ASSESSMENT REPORT

THE DAN LAND MP 06_0031 MOD 3

Figure 4: Proposed modification (Source: Proponent)

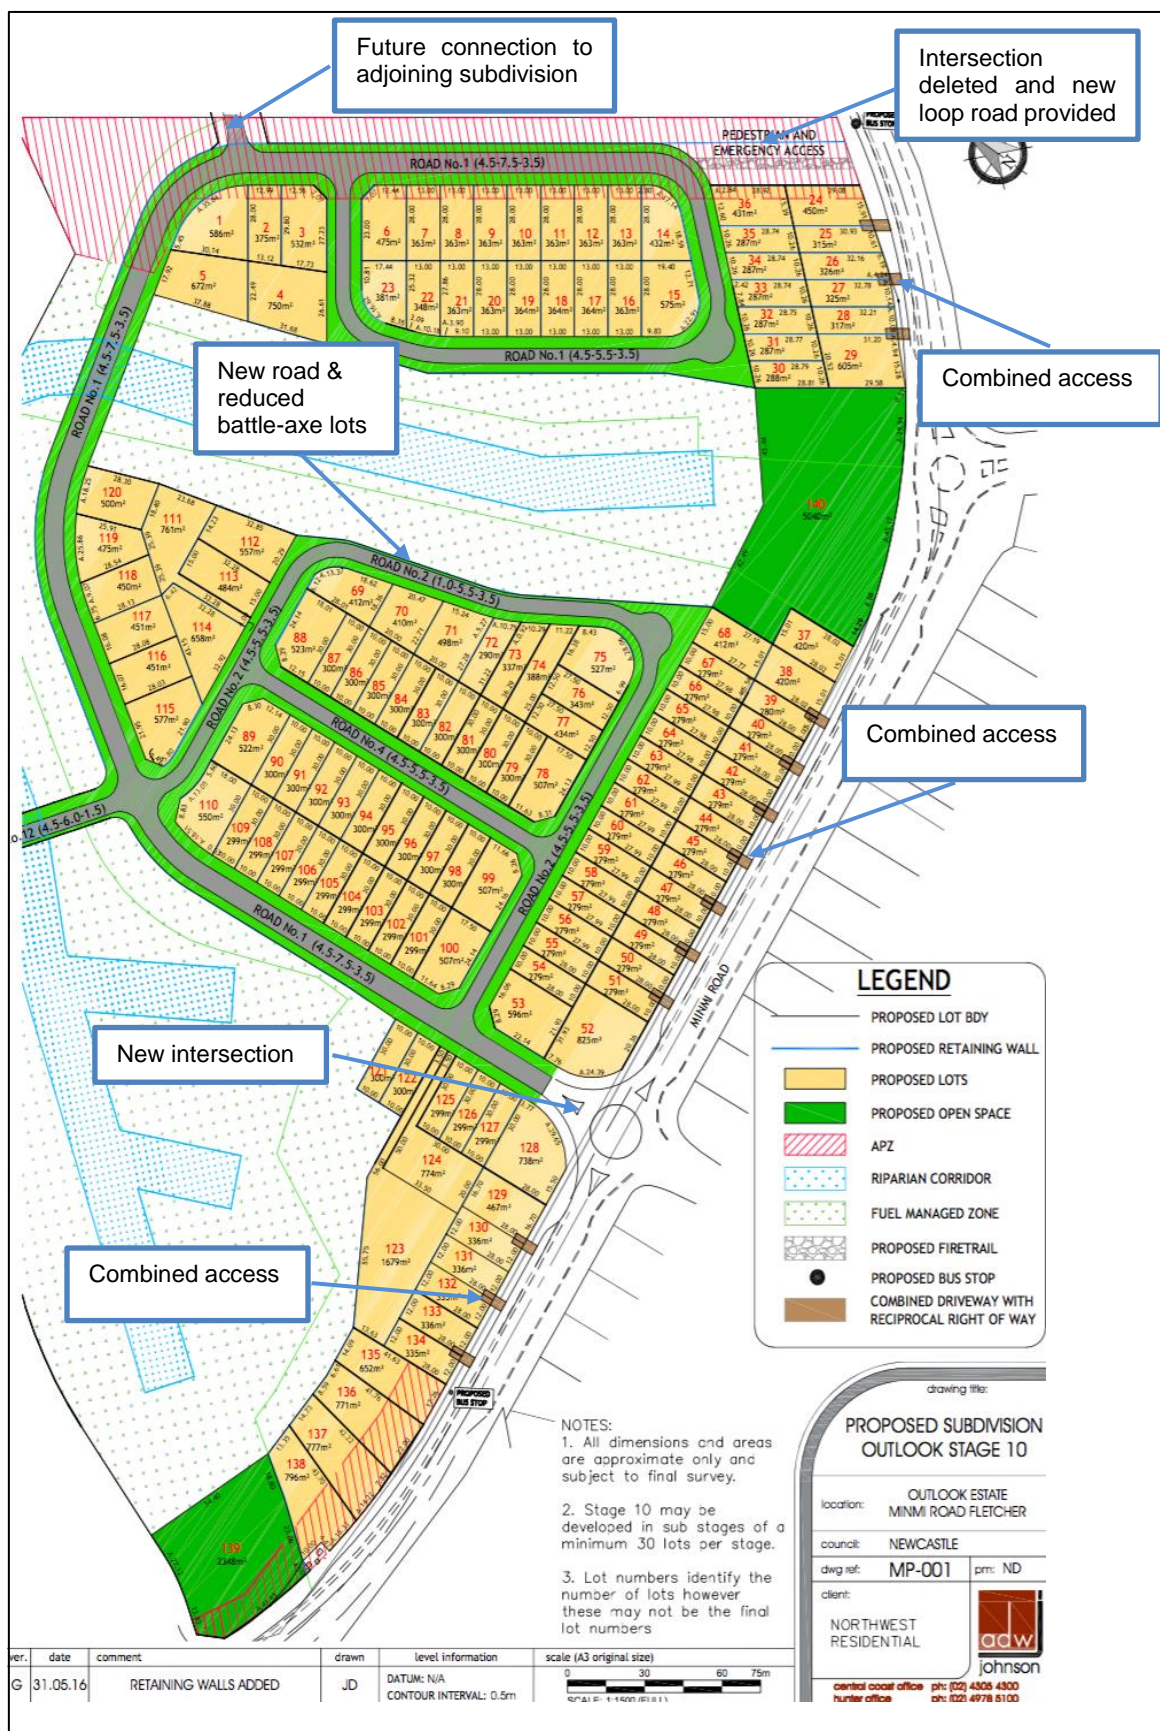
The Proponent prepared a Response to Submissions (RTS) to address issues raised by the Department and Council and subsequently made the following key amendments to the proposed subdivision:

- reduction in the number of battle-axe lots from nine to three lots;
- provision of combined driveways on Minmi Road;
- provision of a new Internal Loop Road (Road 2);
- provision of a road reserve connection to the adjoining residential subdivision to the north east;
- deletion of a reference to footpath widths for local streets; and
- clarification the Proponent seeks approval to discharge Condition B10.

Council raised concern regarding traffic safety impacts resulting from lots gaining direct access off Minmi Road. Council also recommended the subdivision be amended so lots facing Minmi Road could gain access from a rear internal laneway, rather than directly off Minmi Road.

Council reviewed the Proponent's 'Review of Access Issues' and the SAMSA Report and maintained its concern about potential conflicts between traffic, pedestrians and cyclists resulting from direct access off Minmi Road, noting the combined driveways along Minmi Road would only marginally mitigate potential traffic conflicts.

The Department acknowledges Council's concerns, however, based on the findings of the SAMSA Report, the Department is satisfied the proposed access off Minmi Road is acceptable. The Department considers the proposal would not result in any significant traffic safety impacts, particularly given the low speed nature of the road and the traffic calming properties of the existing and proposed roundabouts.

The Department's assessment concludes the proposed access off Minmi Road is acceptable, and would not result in any significant road safety issues. Multiple traffic assessments have been undertaken, concluding the proposal would not unreasonably compromise the safety of vehicles, cyclists or pedestrians. In addition, the recommended condition requiring road safety audits would further ensure any potential safety issues are identified and appropriately addressed.
